SUBJECT: Requests relief from requirements of ASME Boiler & Pressure  
 Vessel Code Section XI re providing main steam to emergency  
 feedwater pump turbine. Exemption of Valve 2MS-84 from  
 hydrostatic pressure test requested.

Subject: Oconee Nuclear Station, Unit 2  
Docket Nos. 50-270

I. Component for which Exemption is Requested:

## ISOMETRIC SKETCH PART II OF III

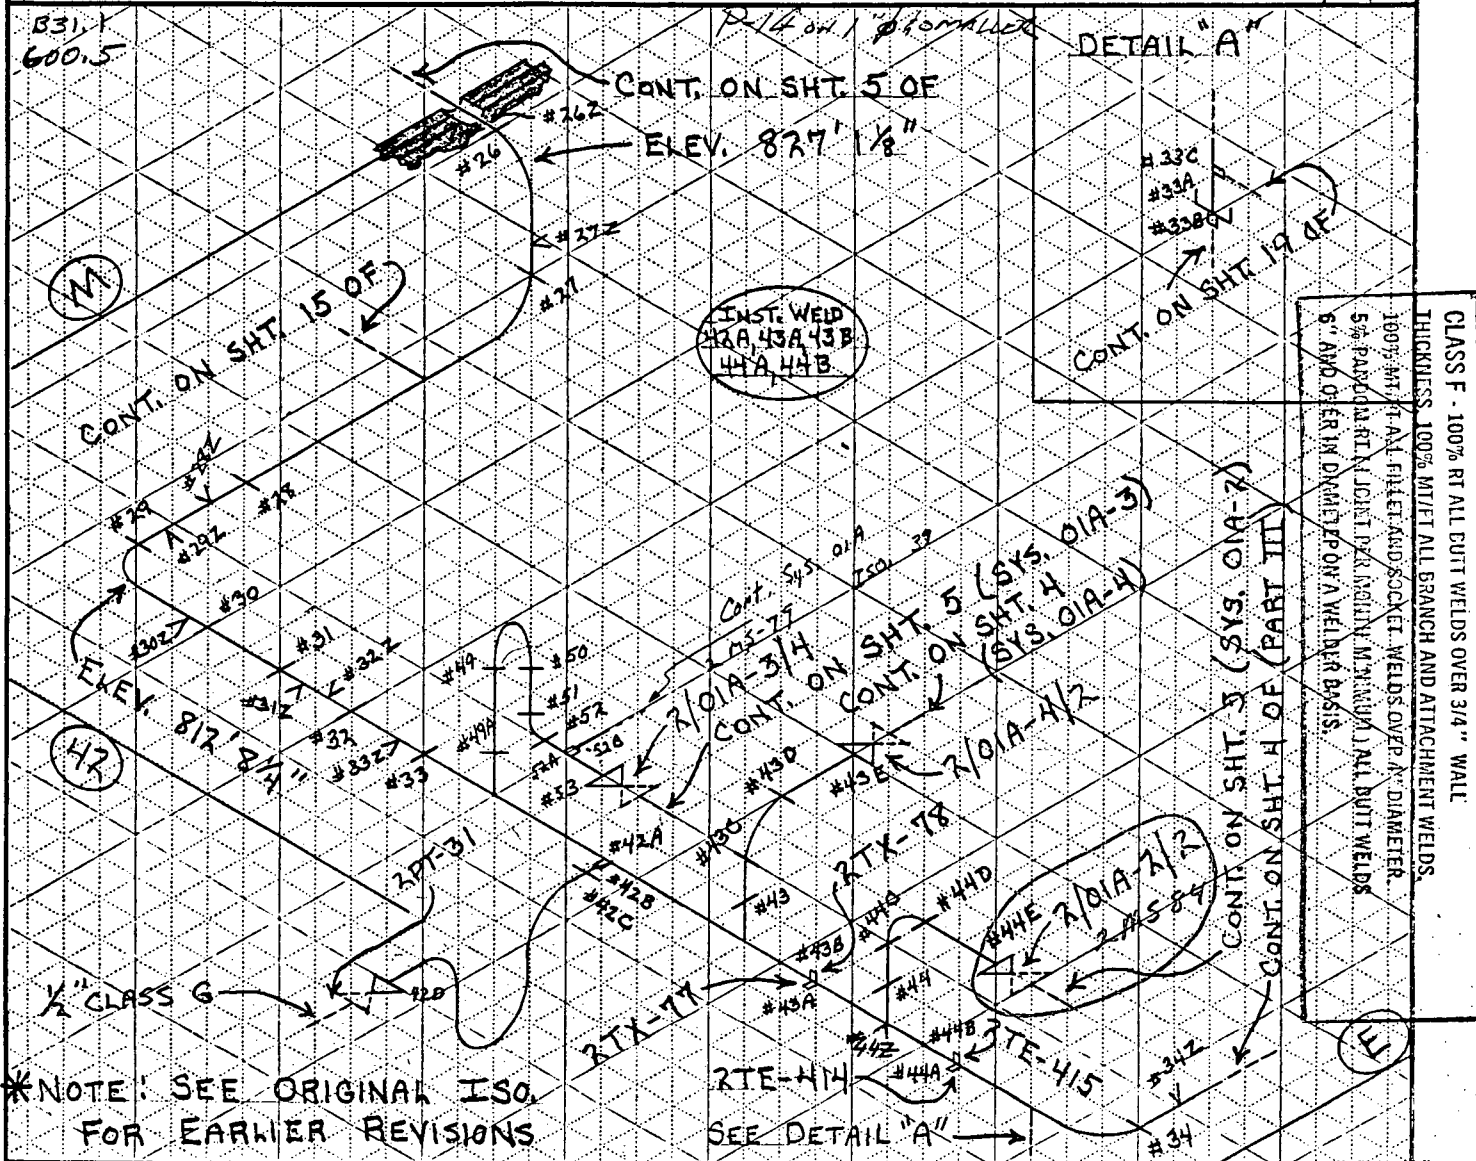
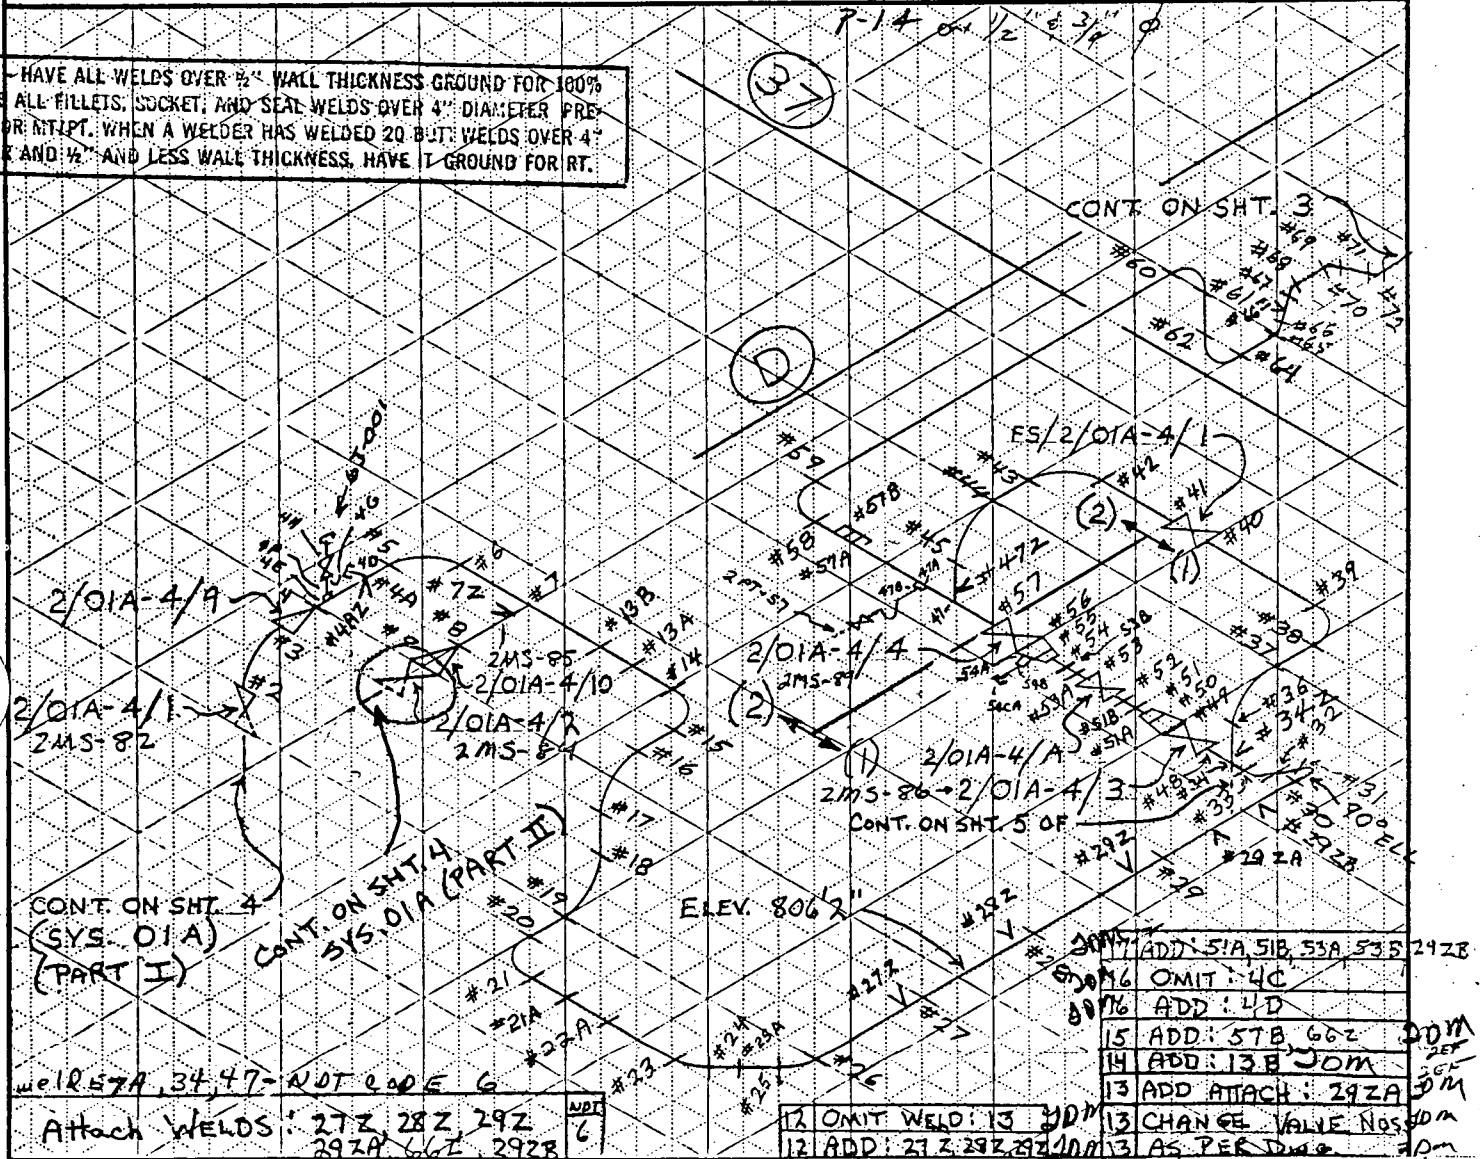
To perform the required hydrostatic test (on the two welds shown in the attached sketch) would require the filling of the Main Steam line with water, and would place additional cycles on the Steam Generator.

Therefore, Duke requests that valve 2MS-84 be considered exempt from the requirements of paragraph IWC-5210(a)(2).

- (a) The welds will be 100% radiographed.
- (b) The welds will also be inspected during the OTSG/MS line hydro as part of the Inservice Inspection Plan.

- (a) Radiograph will be performed prior to Unit 2 startup.
- (b) Hydrostatic testing will be performed during the 10 year Inservice Inspection.
